UNITED STATES PATENT AND TRADEMARK OFFICE

10/823,355

Office Action Summary	Application No. 10/823,355	Applicant(s) MARTINSON ET AL.	
	Examiner MICHAEL BAND	Art Unit 1795

DETAILED ACTION

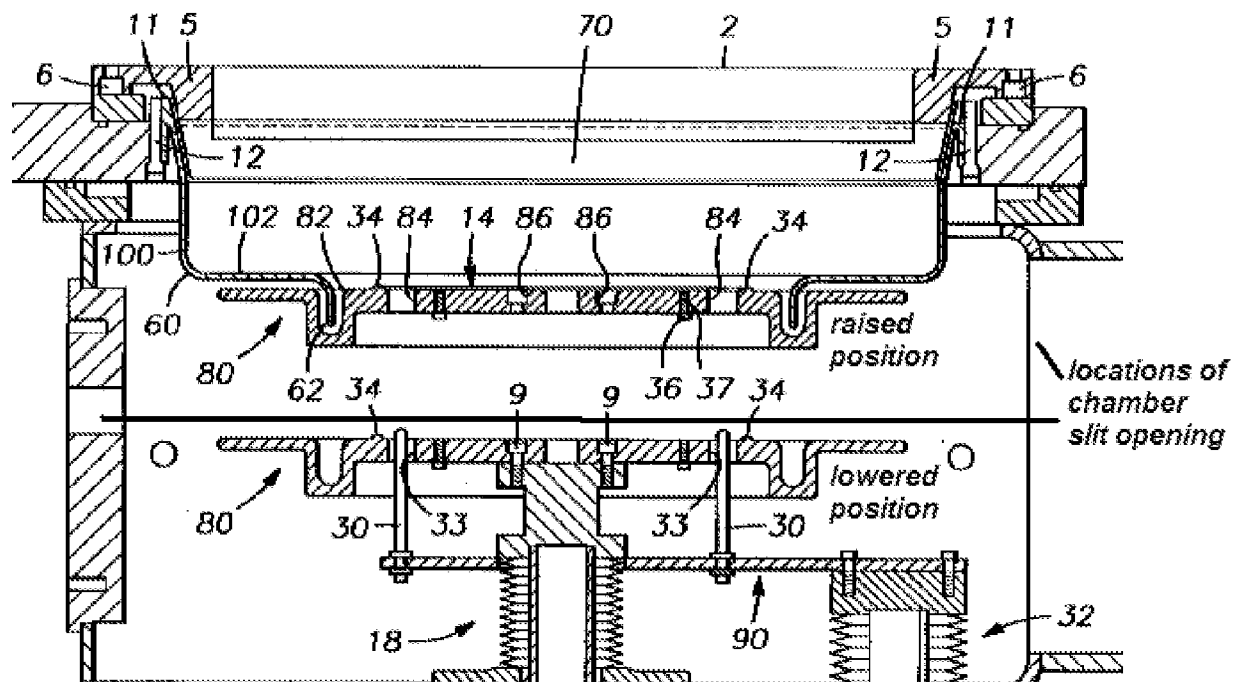
pedestal shield [82] facing the chamber upper walls to the side and lower walls of said chamber [2]. The cropped figure below of fig. 5 serves to further clarify the raised position, the lowered position, the shields 60], [82] avoiding contact with each other, and a robot blade for horizontally transporting the wafer (i.e. substrate) into and out of the chamber [2].

With respect to claims 3-5 and 16, Tepman et al further discloses in fig. 5 the sidewall shield [60] having the lower end [62] disposed below and outward of an upper surface plane of the pedestal shield [82] when said pedestal [18] is raised, with fig. 5 also depicting the pedestal shield [82] having the upper portion surrounding said pedestal [18] and having an outwardly and downwardly extending portion surrounding and extending from said pedestal [18] toward the chamber [2] lower walls. Fig. 5 further

depicts the sidewall shield [60] having the lower end [62] disposed below and outward of the upper surface of the pedestal shield [82] in addition to said lower end [62] being inward of the outward portion of said pedestal shield [82] when the pedestal [18] is raised.

With respect to claims 6-8 and 17-19, Tepman et al further discloses in fig. 5 the pedestal shield [82] having an upper portion surrounding the pedestal [18] and a lower portion extending downward toward the chamber lower wall and an outward portion extending upward and away from said lower portion, with the sidewall shield [60] having a lower end disposed outward of said upper portion of said pedestal shield [82] and inward of said outward portion of said pedestal shield when said pedestal [18] is in the raised position. Fig. 5 also depicts the sidewall shield [60] having an outward portion [102] between the sidewall of the chamber [2] and the lower end of said sidewall shield [60], where said outward portion [102] is disposed outward of the outward portion of the pedestal shield [82] when the pedestal [18] is in the raised position.

With respect to claim 9, Tepman et al further depicts in fig. 5 the sidewall shield [60] having the lower end that is above the pedestal shield [82] when the pedestal [18] is in the raised position, where said pedestal shield [82] extends outward from said pedestal [18] toward sidewalls of the chamber [2] and below said lower end of said sidewall shield [60].

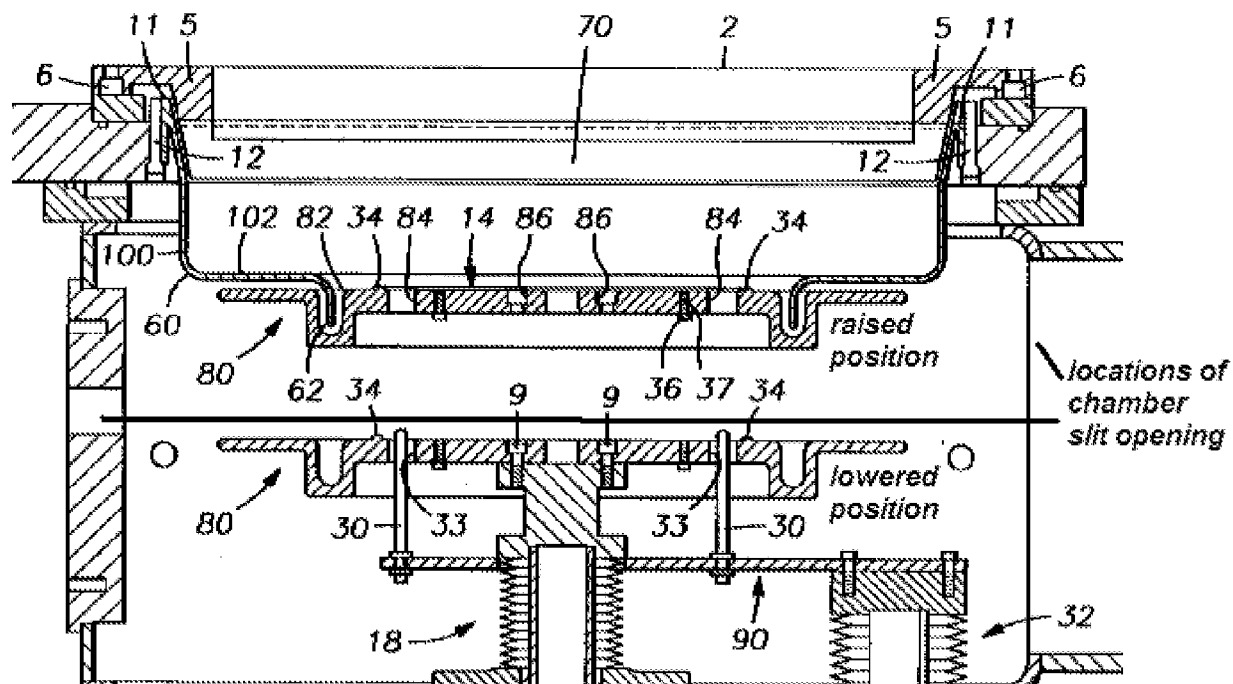
With respect to claims 1-2, 13-15, and 20, Tepman et al discloses an apparatus for full wafer deposition with a sidewall shield arrangement that prevents deposition in the area of a chamber surrounding a substrate (i.e. wafer) (abstract). Tepman et al further discloses in fig. 5 the chamber [2] comprises lower, side, and upper walls, a lifter apparatus [90] for moving a pedestal [80] between a lower unloading position and a raised deposition position, and a sputter target [70] above said pedestal [80]. Fig. 5 further depicts the pedestal [80] having an extended segment (i.e. pedestal shield) [82] that is movable between the raised position and lowered position, with said extended segment [82] having an outwardly and downwardly extending portion surrounding and extending from said pedestal [80] toward the chamber [2] lower walls and an outwardly and upwardly curving end extending toward said chamber [2] side walls. Fig. 5 also depicts a sidewall shield [60] comprises a cylindrical portion [100] that extends around and within the chamber sidewalls along with downward from an upper portion, said sidewall shield [60] having a curved inwardly and downwardly extending portion with a

lower end [62] disposed below an upper portion of the pedestal shield [82] when said pedestal [80] is raised. Fig. 5 further depicts that the lower end [62] is above the pedestal [80] when said pedestal [80] is in the lowered position a distance sufficient to permit a wafer (i.e. substrate) to be horizontally loaded onto said pedestal [80] via slit valve-controlled opening in chamber wall (col. 5, lines 20-49), with said pedestal shield [82] and said sidewall shield [100] cooperating when the pedestal [80] is in the raised position to prevent line-of-sight deposition from the sputter target [70] or gas-scattered transmission of deposition from said sputter target [70] to the side and lower walls of the chamber [2] in addition to preventing line-of-sight or gas-scattered transmission of deposition from sides of the pedestal shield [82] facing the chamber upper walls to the side and lower walls of said chamber [2]. The cropped figure below of fig. 5 serves to further clarify the raised position, the lowered position, the shields 60], [82] avoiding contact with each other, and a robot blade for horizontally transporting the wafer (i.e. substrate) into and out of the chamber [2].

However Tepman et al is limited in that the pedestal shield being attachable to the pedestal is not suggested.

Chung et al further teaches a sidewall shield [48] used for physical vapor deposition with a pedestal [82] having a pedestal shield [84] capable of moving up and down inside a deposition chamber [80] (abstract; figs. 6A-6B). Figs. 6A-6B depict the sidewall shield [48] having an extension to a lower end that extends below the pedestal [82] and forms a bottom wall shield (i.e. inward portion) that extends along a lower wall of the deposition chamber [80], with said bottom wall shield extending upward with a lower portion of the pedestal shield [84] between said extension and said bottom wall shield. Chung et al also teaches the pedestal shield [84] being attachable to the pedestal [82] (col. 6, lines 59-64).

It would have been obvious to one of ordinary skill in the to substitute the two-piece pedestal shield and pedestal as taught by Chung et al in place the single-piece

pedestal shield and pedestal of Tepman et al to attain the predictable result of blocking line-of-sight to prevent deposition particles from depositing on the chamber sidewalls and bottom. It further would have been obvious to one of ordinary skill in the art to have the pedestal shield attachable (i.e. removable) to the pedestal since it has been held that if it were desirable for any reason to obtain access to the pedestal, it would be obvious to make the pedestal shield removable for that purpose. See MPEP 2144.04, Section V, Part C. In this case, it is desirable to remove only the pedestal shield in order to replace or clean said pedestal shield due to deposited material while leaving the pedestal in place, thus it is obvious to make said pedestal shield removable. It further would have been obvious to one of ordinary skill in the art to use the two-piece pedestal shield and pedestal taught by Chung et al to prevent deposition particles from depositing on the chamber sidewalls and bottom as taught by Tepman et al since using a known technique of pedestal shields for preventing deposition material accumulating on the chamber sidewalls and bottom is desired in Tepman et al. It further would have been obvious to one of ordinary skill in the art to try using the two-piece arrangement of Chung et al in attempt to improve the single-piece arrangement of Tepman et al, as a person with ordinary skill has good reason to pursue the known options within his or her technical grasp since the pedestal shield is either permanently attached to the pedestal (i.e. single-piece) or removable (i.e. two-piece).
